**REQUEST FOR BIDS (RFB)  
FOR  
INSTALLATION OF FENCING  
IN TERMINAL AREA**

**FOR  
ROBERTSON AIRPORT  
TOWN OF PLAINVILLE, CT**

**ADDENDUM NO. 1  
ISSUE DATE: 4/18/2023**

**INSTALLATION OF FENCING IN TERMINAL AREA  
ROBERTSON AIRPORT  
Plainville, Connecticut**

**KEYPAD READER DETAIL**  
NOT TO SCALE

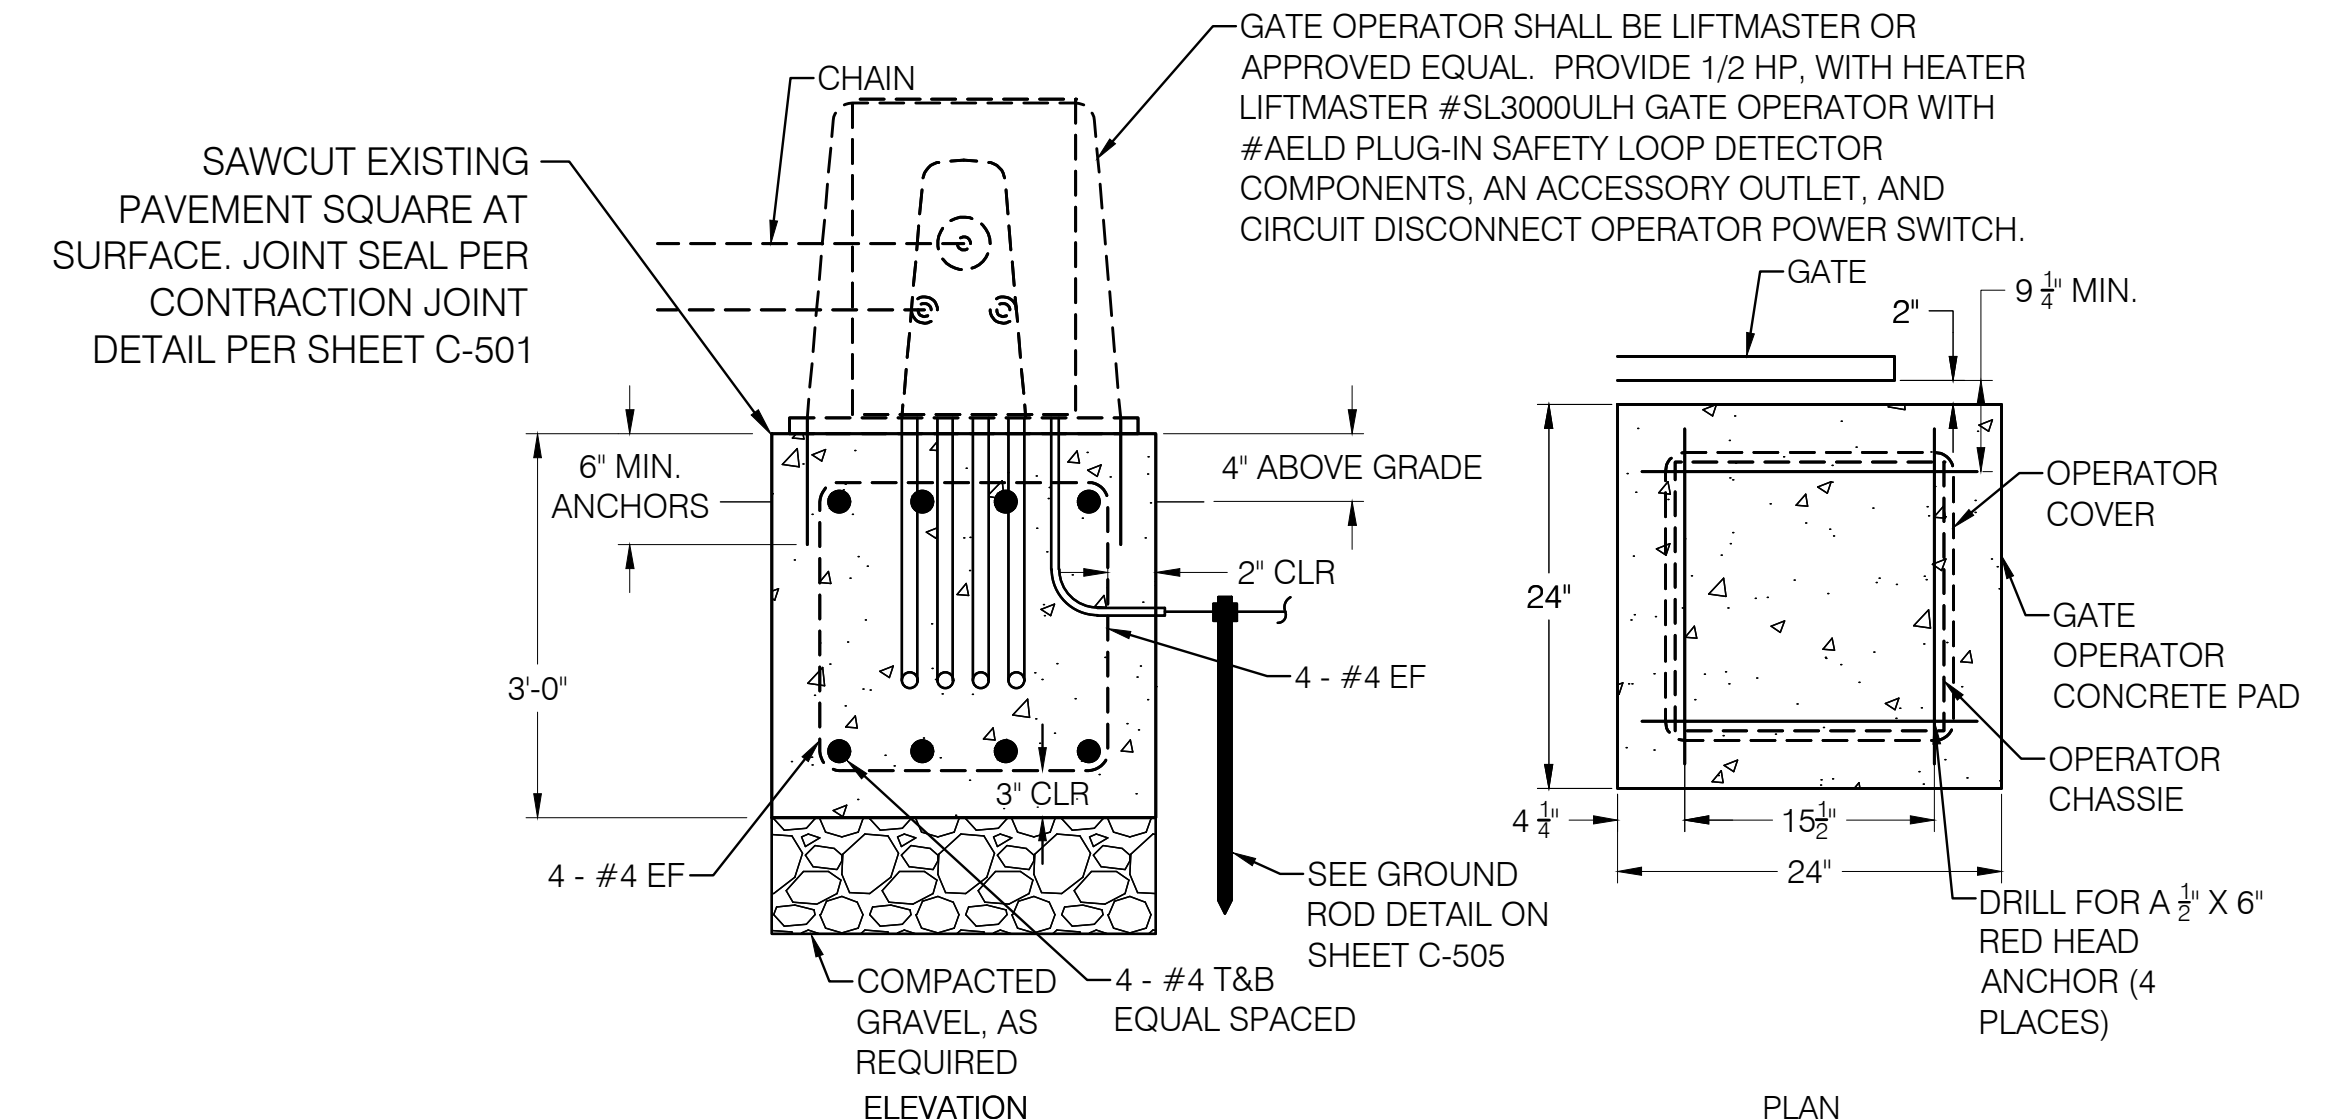
7. **REVISE:** The callout for Keypad Reader Detail on sheet C-504 has been modified to better specify the existing emergency access system used by the town.

1. **KEYPAD READER DETAIL – Callout:**

~~KNOX BOX MODEL#3502 SINGLE KEY SWITCH WITH FIRE DEPT LABEL. COORDINATE WITH THE TOWN OF PLAINVILLE OFFICE OF THE FIRE MARSHALL TO ARRANGE FOR CUT KEY~~  
**PROVIDE EMERGENCY ACCESS SYSTEMS, INC. (WWW.EASKEYBOXSYSTEMS.COM) ELECTRIC KEY SWITCH AND ASSOCIATED MOUNTING EQUIPMENT. KEY SWITCH SHALL MEET ALL REQUIREMENTS OF THE TOWN OF PLAINVILLE, OFFICE OF THE FIRE MARSHALL. COORDINATE WITH THE FIRE MARSHALS' OFFICE, GATE OPERATOR EQUIPMENT MANUFACTURER, AND KEY SWITCH MANUFACTURER AS REQUIRED TO APPROPRIATELY INSTALL THE KEY SWITCH.**
